- 3. Ninilchik Townsite Vane 2023 Replat
KPB File 2022-182
Peninsula Surveying LLC / Vanek
Location: Bayview Street & Mission Avenue
Ninilchik Area**

ITEM 3 - NINILCHIK TOWNSITE VANEK 2023 REPLAT

KPB File No.	2022-182
Plat Committee Meeting:	January 23, 2023
Applicant / Owner:	Betsy and Rion Vanek of Ninilchik, Alaska
Surveyor:	Jason Schollenberg / Peninsula Surveying, LLC
General Location:	Mission Avenue, Bayview Street, Ninilchik area

STAFF REPORT

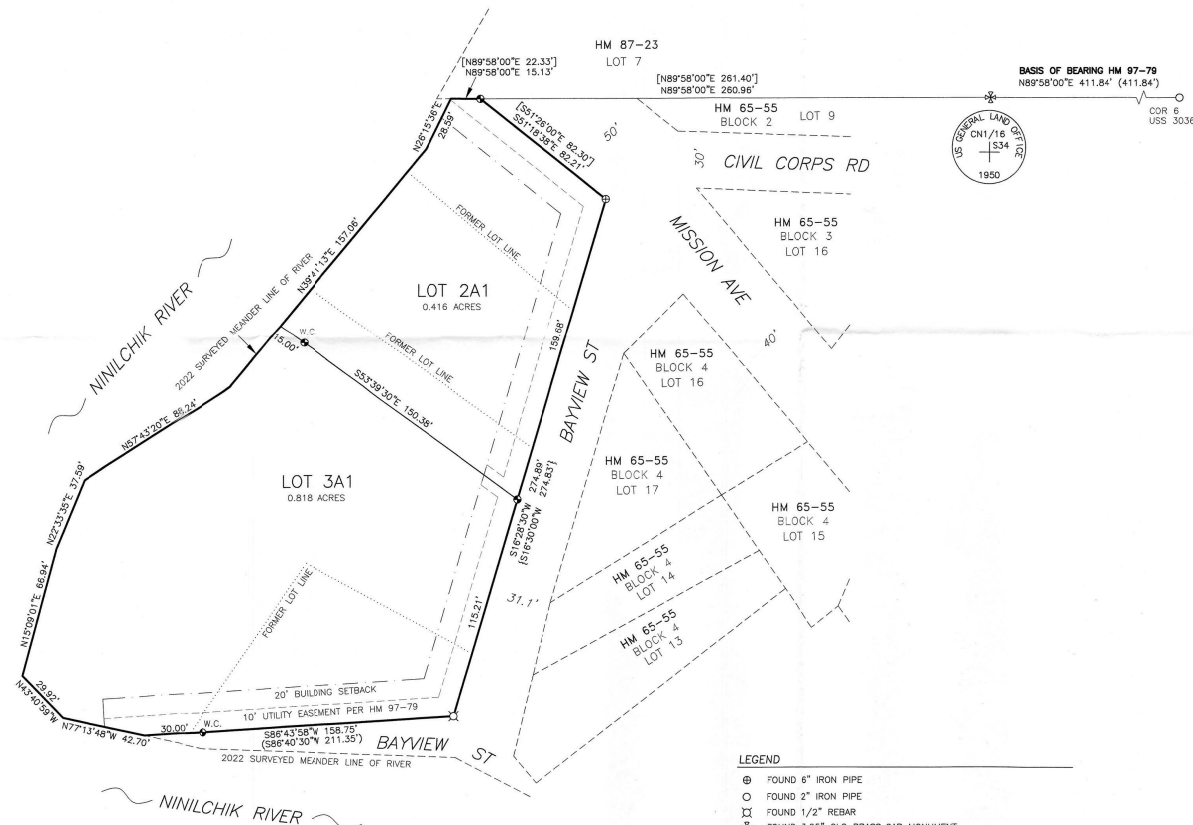
The property shows the 2022 surveyed meander of the Ninilchik River. **Staff recommends the source or method for finding the meander should be noted or provided within a note, and a note regarding natural meander is for computations only should be added.**

The proposed subdivision is within multiple Flood Hazard Zones. The majority is within X which is minimal risk and is non-regulatory. Portions within the western and southern areas are within AE zone. The AE zone is regulatory and has a 1% annual chance of flooding. **Staff recommends the AE zone boundary be shown on the plat and the required flood hazard note be added.**

The Ninilchik River is an anadromous stream. **Staff recommends the anadromous waters habitat protection district note is required to be added.**

There are multiple structures on the property. It appears the removal and movement of lot lines will fix any encroachment issues within the subdivision boundary. Per KPB GIS Imagery, there may be a structure within the Bayview Street dedication. Additionally, some of the structure may be close to the building setbacks and utility easements. Parent Lot 1 was not subject to a setback or platted utility easement until this plat is recorded. The remainder of the subdivision had setbacks put into place with Ninilchik Townsite Jackinsky-Vanek Replat, HM 97-79. If it can be proven buildings existed prior to setback creations plat notes may be added that they are exempt. **Staff recommends all structure locations be verified, if any permanent structures are found within the rights-of-way, setbacks or utility easements additional requirements or notes may be required, if no encroachment issues are found this should be disclosed in writing.**

Per the Certificate to Plat there is a cabin on the property that was sold. There is no mention if the cabin was to be later relocated or what the access rights are to the cabin. **Staff recommends if the cabin is still present to depict on the plat with a reference to a plat note with the information regarding the sale of the cabin.**

An easement for a leach field is shown on the Certificate to Plat. The easement affects Lot 3A Block 5. This easement is for the benefit of Lot 13 Block 4. **Staff recommends a plat note be added with the information regarding the easement.**

Utility Easements A recorded easement to ACS is within the Certificate to Plat. The easement is within parent Lot 1. The easement states the location and it should be depicted on the final plat. This plat will be granting utility easements along the rights-of-way for those not previously granted. If it is found that the ACS easement will be within a new or already granted utility easement it does not require depiction but a reference to a plat note. **Staff recommends a plat note be added with the information regarding the ACS easement and if within another existing easement state as such.**

Parent lots 2A, 3A, and 4A had 10 foot utility easements granted along the rights-of-way that increased to 20 feet within 5 feet of the side lot lines. Parent Lot 1 does not have any platted easements to carry over. **Staff recommends the depiction of the utility easements be updated to include the 20 feet within 5 feet of the former side lot lines as they apply.**

This plat is proposing to grant 10 foot utility easements that increase to 20 feet within 5 feet of the side lot lines. These are depicted and noted on the plat. **Staff recommends** the portion of the utility easement within parent Lot 1 should include "granted by this plat".

*Update the plat note numbers.
Add KPB number*

- G. The status of adjacent lands within 100 feet of the proposed subdivision boundary or the land status across from any dedicated rights-of-way that adjoin the propose subdivision boundary, including names of subdivisions, lot lines, block numbers, lot numbers, rights-of-way; or an indication that the adjacent land is not subdivided;
Staff recommendation: *Provide a width label for the portion of Bayview Street located south of the plat even though the river takes up a portion.*

- H. Approximate locations of low wet areas, areas subject to inundation, areas subject to flooding or storm water overflow, and the line of ordinary high water. This information may be provided on an additional sheet if showing these areas causes the preliminary plat to appear cluttered and/or difficult to read;
Staff recommendation: *Not shown. The entire subdivision is low wet areas and within a floodplain. Notes will be required.*

- J. Block and lot numbering per KPB 20.60.140, approximate dimensions and total numbers of proposed lots;
Staff recommendation: *Include a block label within the lots to carry over the block designation.*

- N. Apparent encroachments, with a statement indicating how the encroachments will be resolved prior to final plat approval;
Staff recommendation: *Verification of structure locations will be needed.*

Staff recommendation: Block label needed.

- "No access to state maintained rights-of-way permitted unless approved by the State of Alaska Department of Transportation."
- FLOOD HAZARD NOTICE:
Some or all of the property shown on this plat has been designated by FEMA as a flood hazard area district as of the date this plat is recorded with the district recorder's office. Prior to development, the Kenai Peninsula Borough floodplain administrator should be contacted for current information and regulations. Development must comply with Chapter 21.06 of the Kenai Peninsula Borough Code. Map panel 02122C-1620E.

- ANADROMOUS WATERS HABITAT PROTECTION DISTRICT NOTE:
Portions of this subdivision are within the Kenai Peninsula Borough Anadromous Waters Habitat Protection District. See KPB Chapter 21.18, as may be amended, for restrictions that affect development in this subdivision. Width of the habitat protection district shall be in accordance with KPB 21.18.040.

- *Subject to an easement for leach field access as recorded on November 23, 2020 as serial number 2020-004045-0, HRD.*
- *A cabin located on parent Lot 3A Block 5, Ninilchik Townsite Jackinsky-Vanek Replat, Plat HM 97-79 had title severed by a Bill of Sale recorded on September 23, 2022 as Serial Number 2003-004786-0, HRD.*

- *The natural meanders of mean high water line is for area computations only, the true corners being on the extension of the sidelines and the intersection with the natural meanders.*
